# **BUTTE REGIONAL TRANSIT OPERATIONS CENTER**

Tenant Improvement

## **ADDENDUM NO. 3**

1/18/2016

3 ELECTRIC WATER HEATER DETAIL  
1/4" = 1'-0"

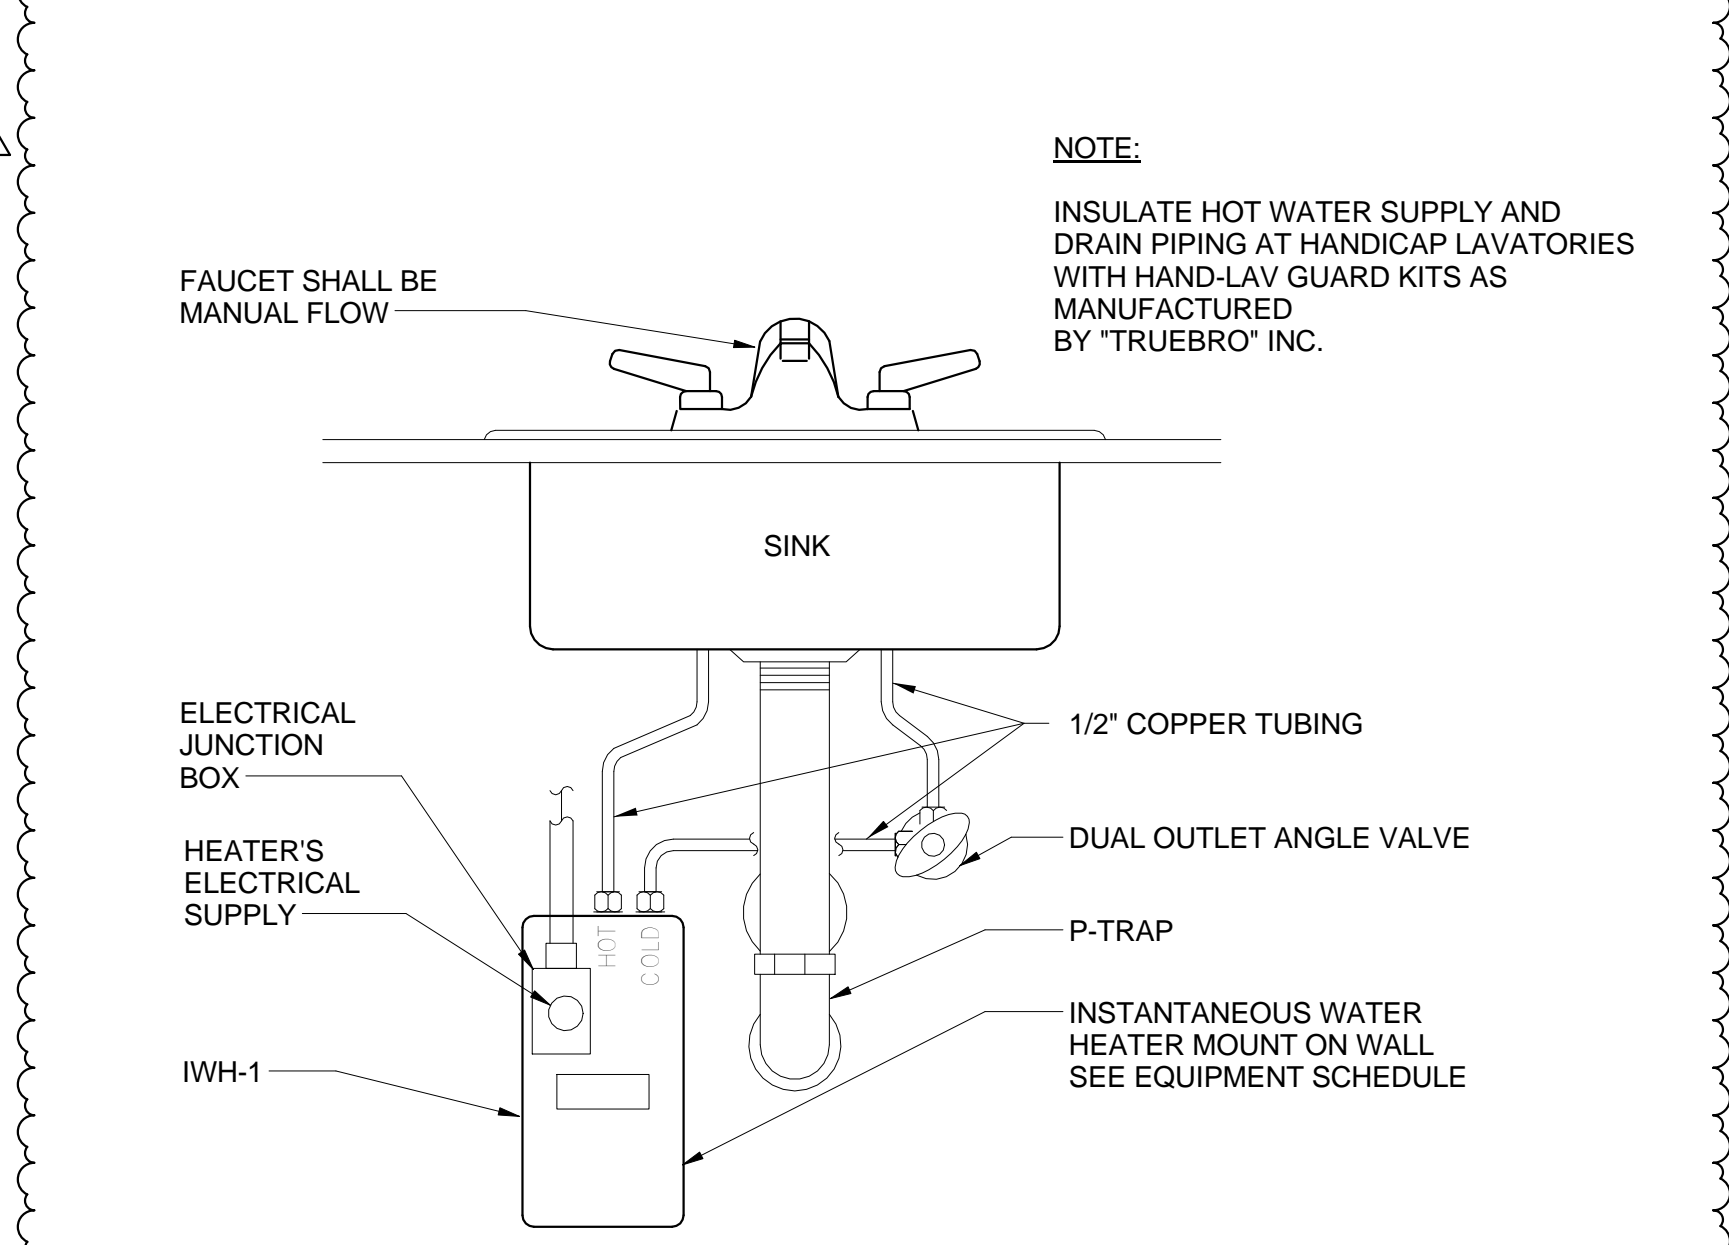
- b. Added Electric Water Heater Detail.
  - c. Added Instantaneous Water Heater Detail.
  - d. Revised plan to locate electric water heater.
  - e. Revised plan to locate instantaneous water heater.

1 ISOMETRIC - WASTE & VENT

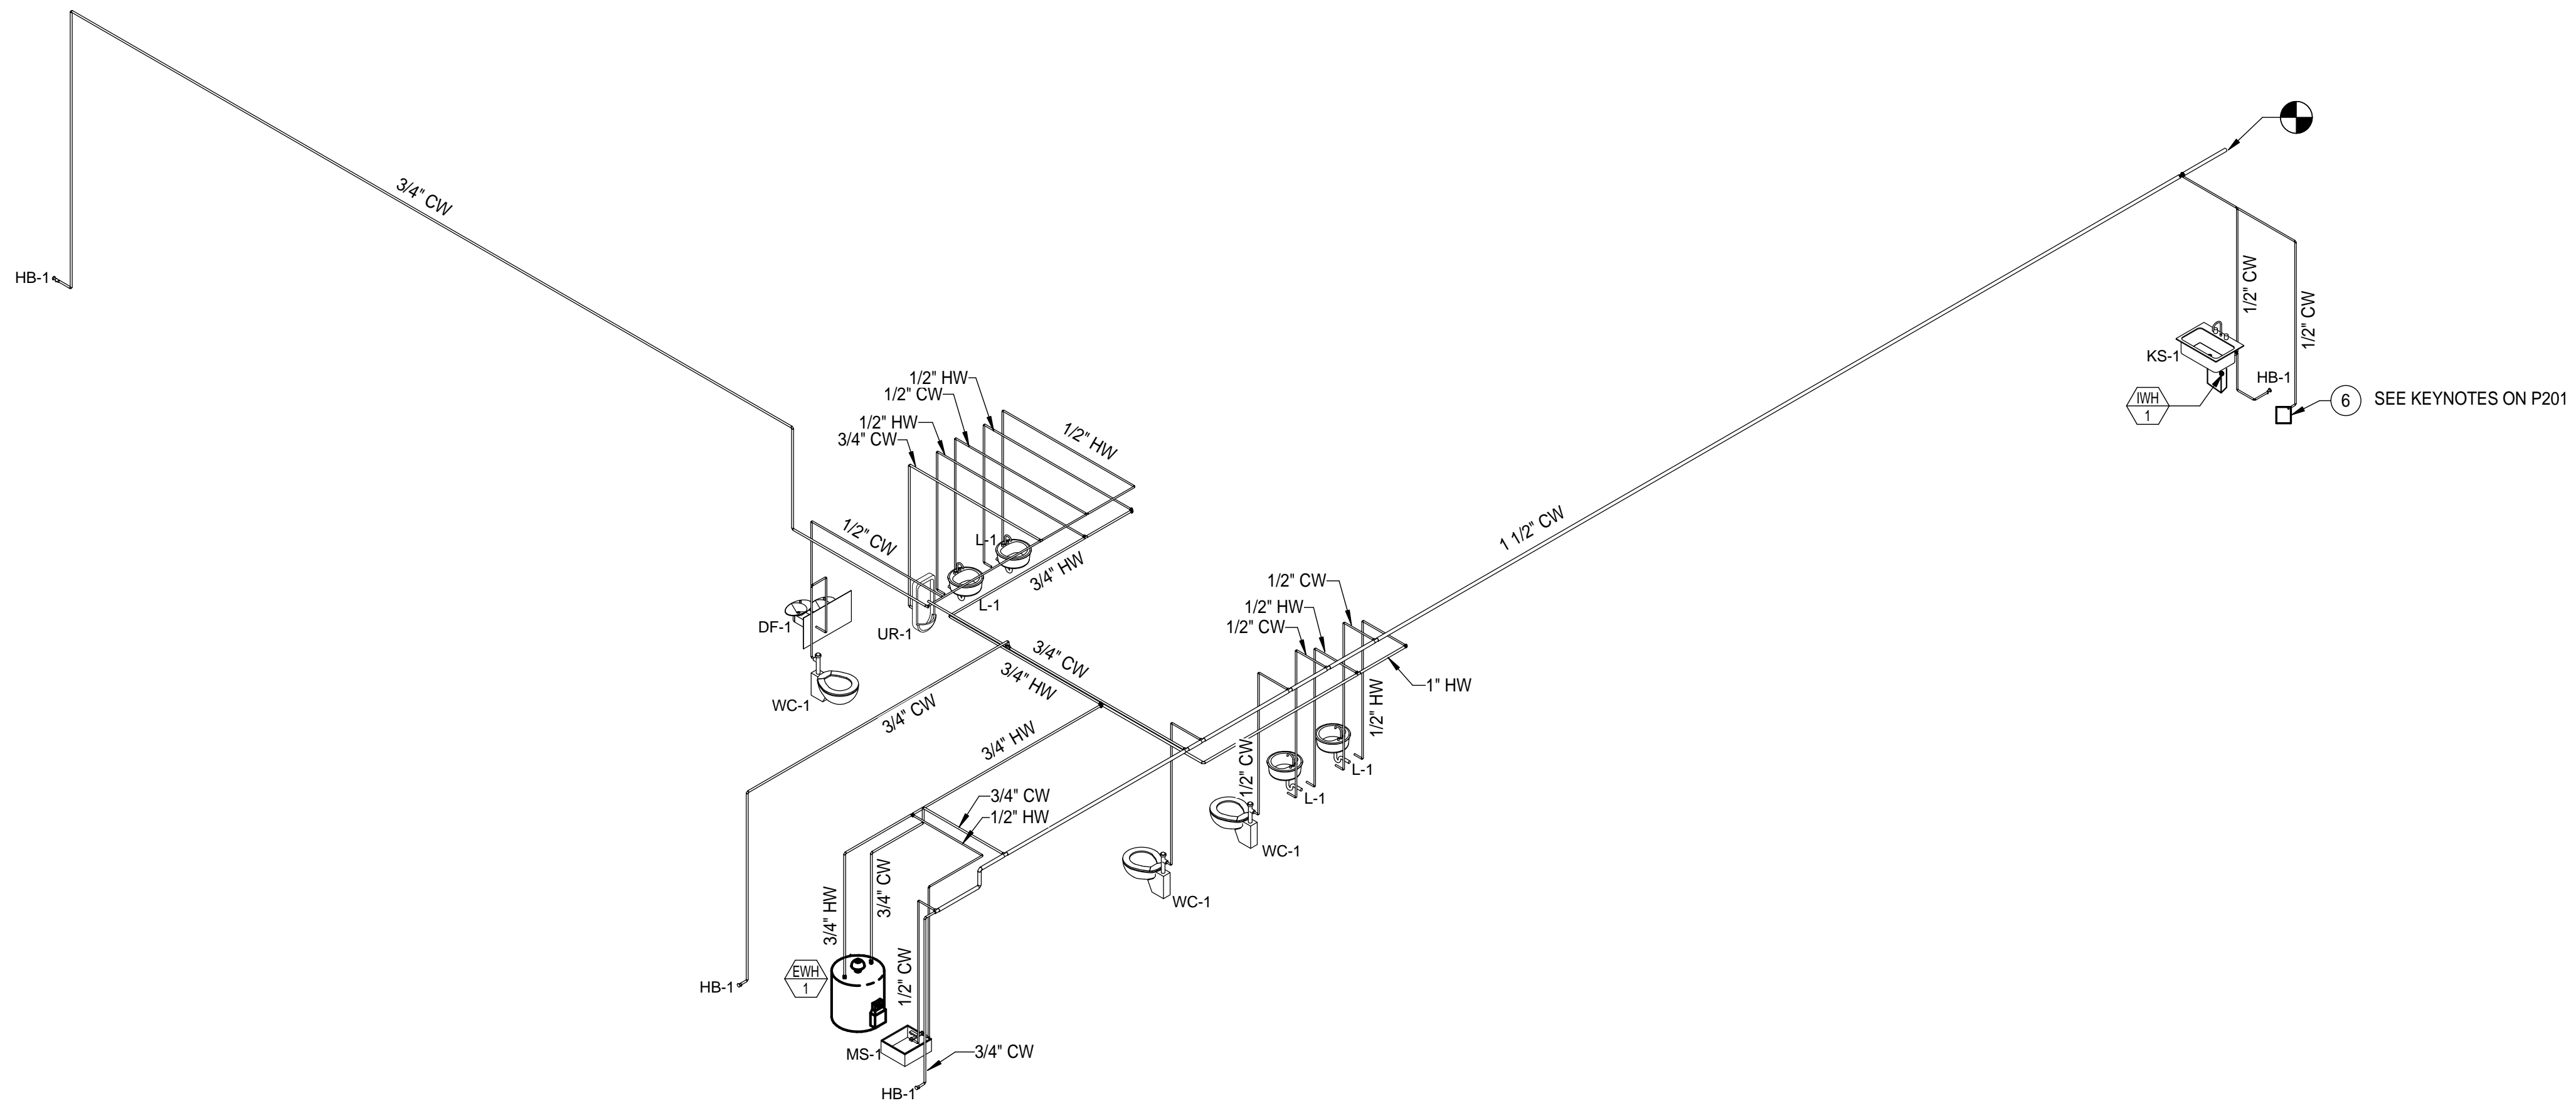
- 1.20 REVISION TO DRAWING P901 – ISOMETRIC PLUMBING VIEWS
  - a. Isometric plumbing plans added for clarity.
- 1.21 REVISION TO DRAWING E201 – ELECTRICAL POWER PLAN
